HOUSTON PLANNING COMMISSION

AGENDA

MAY 9, 2019

ITEM: 89

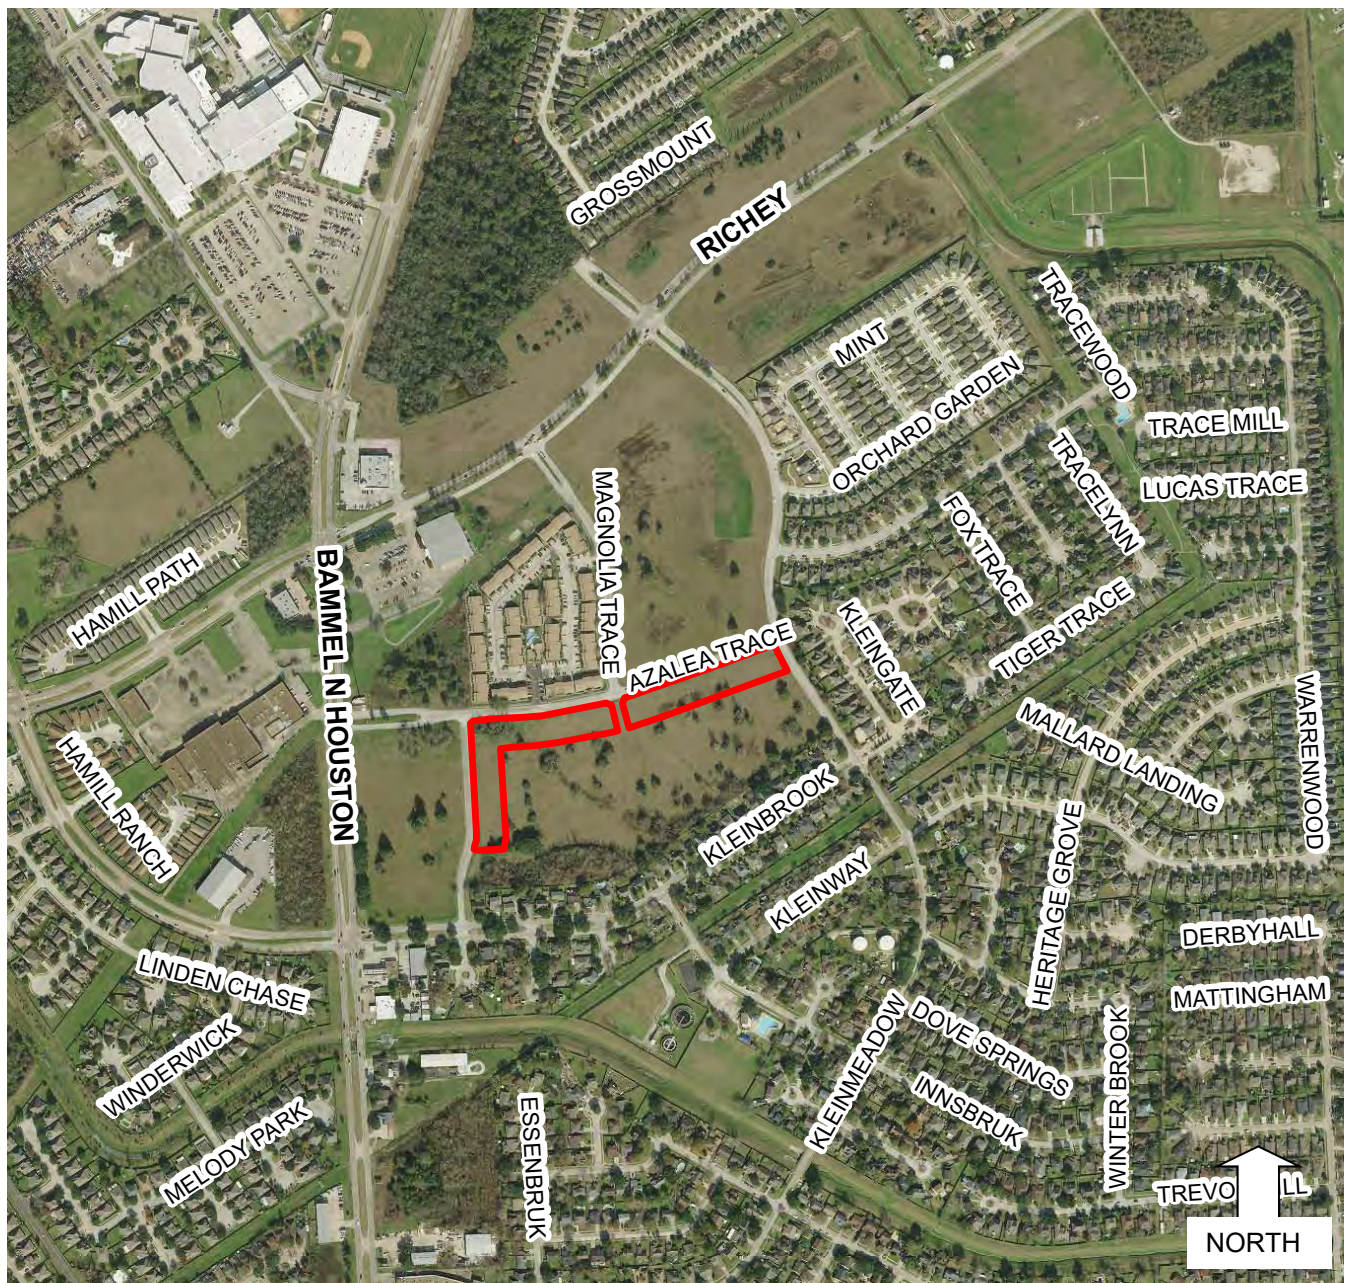
Parks and Recreation: Plat states 4 Dwelling Units, but subdivision plat only shows two lots.

ITEM: 91

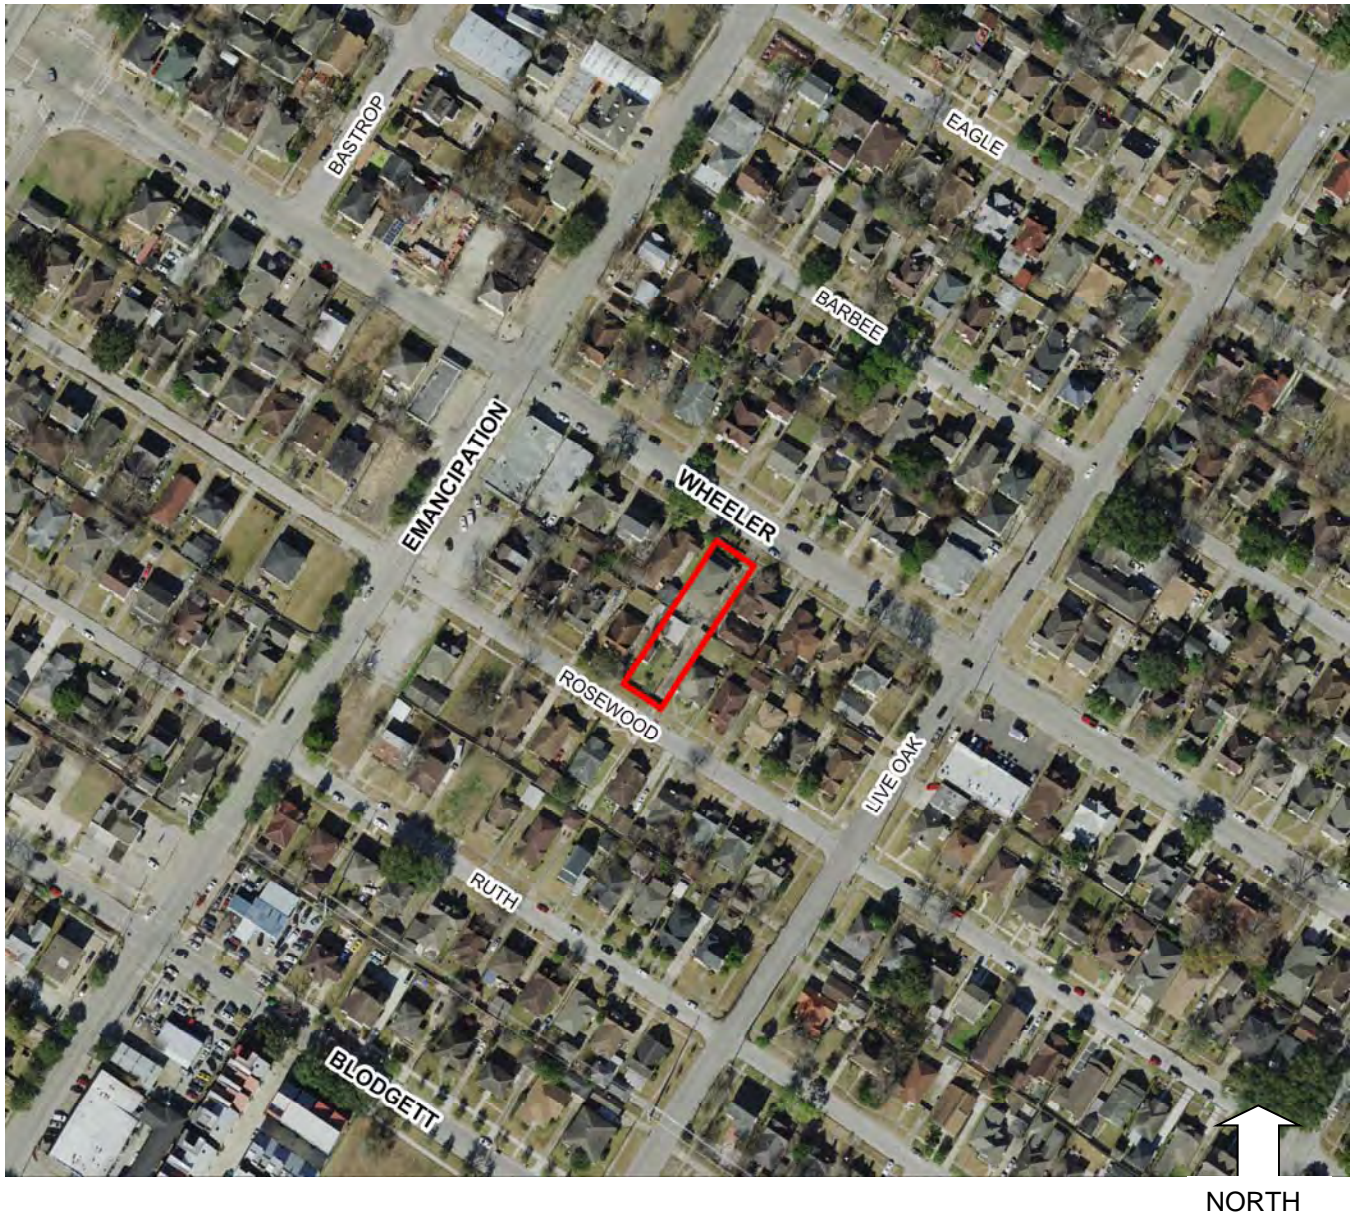
Parks and Recreation: Parks sector is incorrect in plat notes.
